UNITED STATES PATENT AND TRADEMARK OFFICE

APPLICATION NO.	FILING DATE	FIRST NAMED INVENTOR	ATTORNEY DOCKET NO.	CONFIRMATION NO.
10/598,436	08/30/2006	Young-Joo Oh	B1180/20057	5030

Office Action Summary	Application No. 10/598,436	Applicant(s) OH ET AL.	
	Examiner JUSTIN LOFFREDO	Art Unit 3744

DETAILED ACTION

Rode – Figure 3

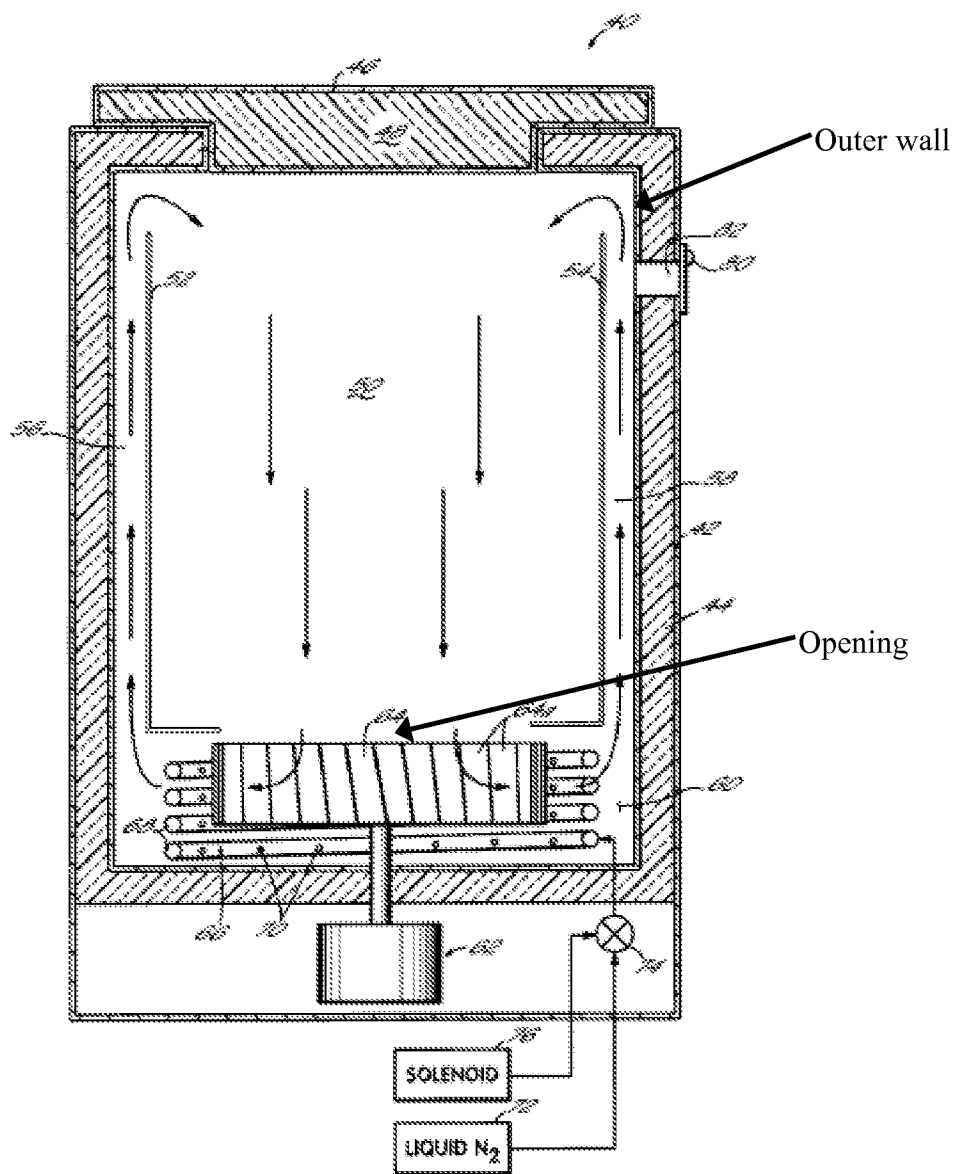
Consider claim 21. Rode discloses cooling equipment (40) for cooling a cooled material, said cooling equipment comprising: a cooling space (50) capable of receiving the cooled material; inner walls (52) and (54) limiting the cooling space (50); an outer wall (see Figure 3 below); plenums (56), (58) and (60), which make up the claimed intermediate space between the outer wall and the inner walls (52) and (54); and a perforated tube (66) (corresponding to the claimed cooling agent supply line) communicating with and emptying into the intermediate space for introducing a cooling agent, whereby most of the liquid cooling agent (i.e. not all of the liquid cooling agent is necessarily vaporized, and thus, some of the liquid cooling agent is introduced in the intermediate space (see col. 1, L 59-col.2, L 7)), wherein the cooling agent supply line (66) empties into the intermediate space between the inner walls (52) and (54) and the outer wall, and continuously transfer the cooling agent into the cooling space (col. 3, L 10-48; Fig. 3).

space not vaporized in the cooling agent supply line, thereby preventing the formation of a cooling agent lake at the bottom of the cooling space. Additionally, while it does appear that a cooling agent lake could form within plenum (60) around the coil (68), claim 21 recites that “no cooling agent lake forms *on a bottom of the cooling space*” (lines 13-14). The opening provided at the bottom of the cooling space (50) of the apparatus disclosed by Rode would prevent the formation of a cooling agent lake at the bottom of the cooling space as recited in the claim (see Rode, annotated Fig. 3).

11. In response to applicant's argument (Remarks at 6) that Rode does not teach the following: a cooling agent supply line communicating with and emptying into the intermediate space; or that the cooling agent is in liquid form; examiner respectfully disagrees. Refer to the rejection of claim 21, in which examiner identified that Rode does in fact disclose these limitations, which is further illustrated by Fig. 3 of Rode's disclosure.

Binder – figure 4

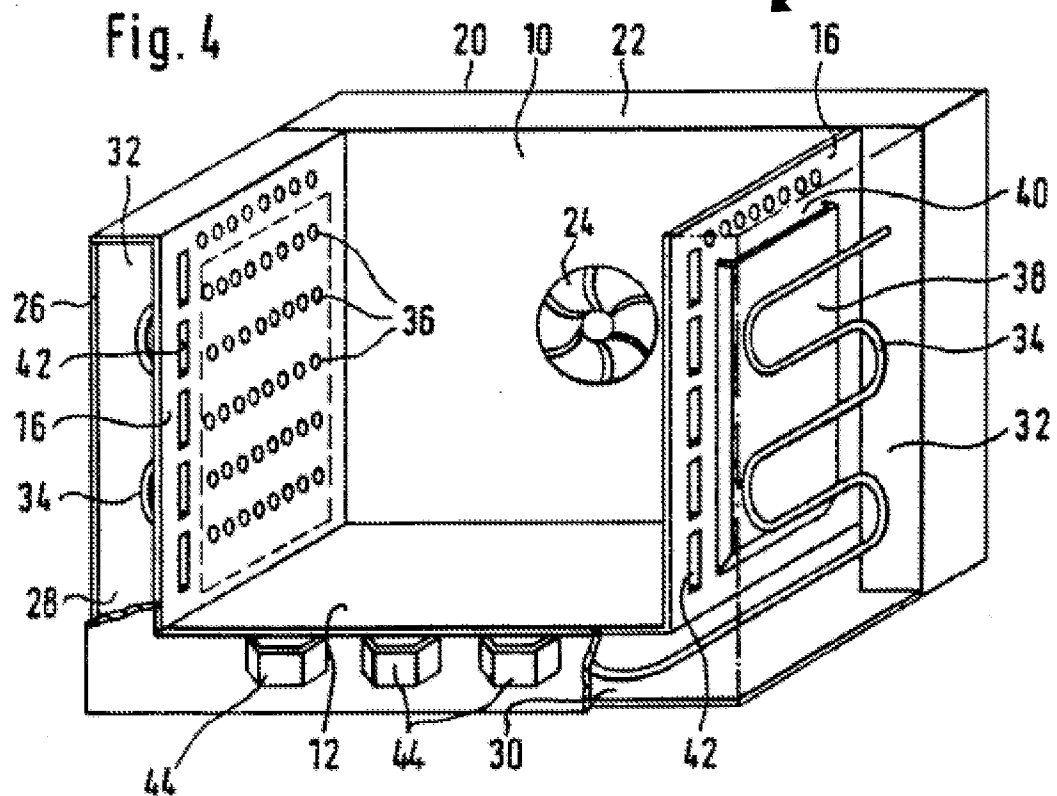
Consider claim 24. Rode as modified discloses the invention as claimed but fails to disclose the inner wall being substantially grid shaped. Binder teaches inner walls (18) of a limiting a space (10), the inner walls (18) having a plurality of apertures (38) (corresponding to the inner wall being substantially grid shaped). The apertures are clearly positioned on a network of substantially uniformly spaced horizontal and perpendicular lines (see Figure 4), which renders the wall substantially grid shaped (col. 3, L55-60; Figure 4). It would have been obvious to one of ordinary skill in the art at the time of the invention to modify the inner wall of the cooling device disclosed by Rode as modified to be substantially grid shaped as taught by Binder in order to produce a connection between the cooling space and the inner wall that allows refrigerant to flow into the cooling space in a uniform manner.
